CITY OF TOMBSTONE
WATER INFRASTRUCTURE IMPROVEMENT UPGRADES
CAP AZ 8370
PRE-BID CONFERENCE MEETING NOTES
March 14, 2017 9:00 A.M.

FIGURE 1
WELL SITE NO. 1 CONCEPTUAL PIPE LAYOUT
TOMBSTONE WATER INFRASTRUCTURE
IMPROVEMENT PLANS

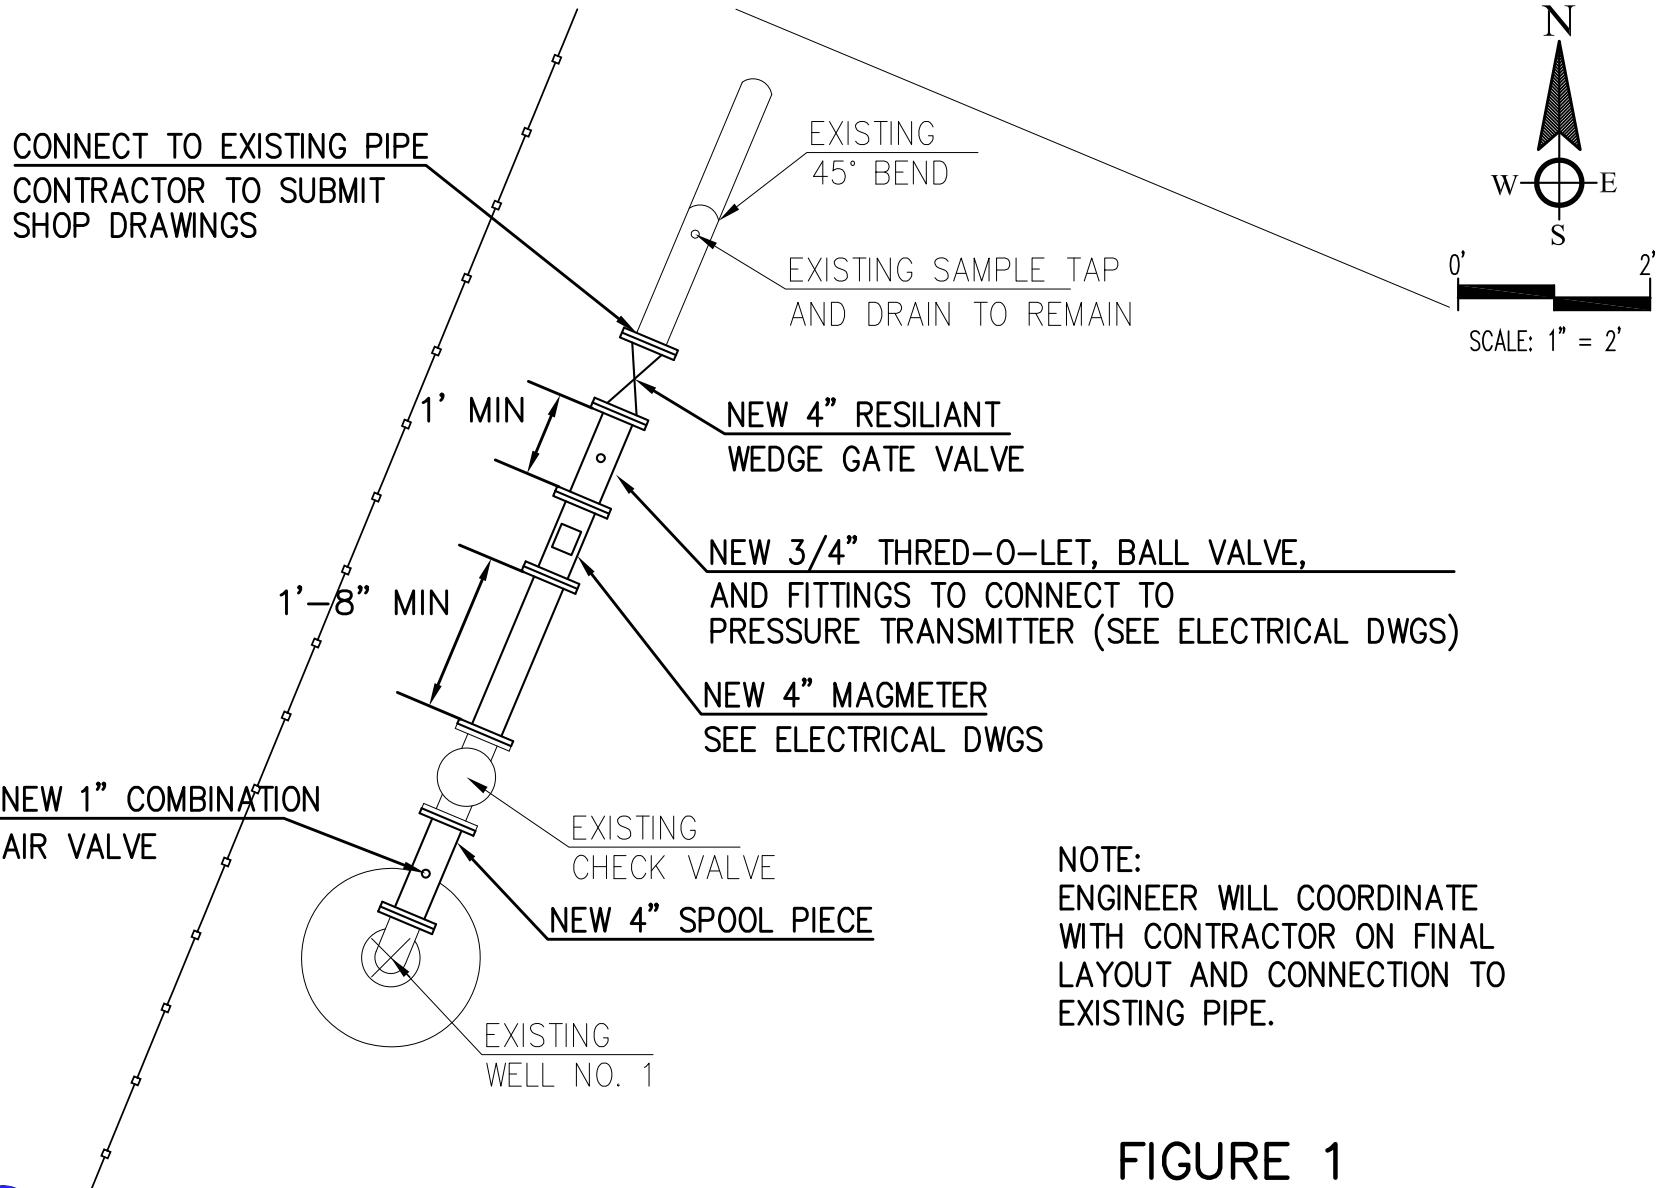
- Q17. Well Site 1: The Contractor would like to request a sketch or drawing of the expected piping that is to be completed at this well.**
A17. Please see Addendum #2

- Q20. Well Site 1: Where is the pressure sensor Thread-O-Let to be placed on this piping run?**
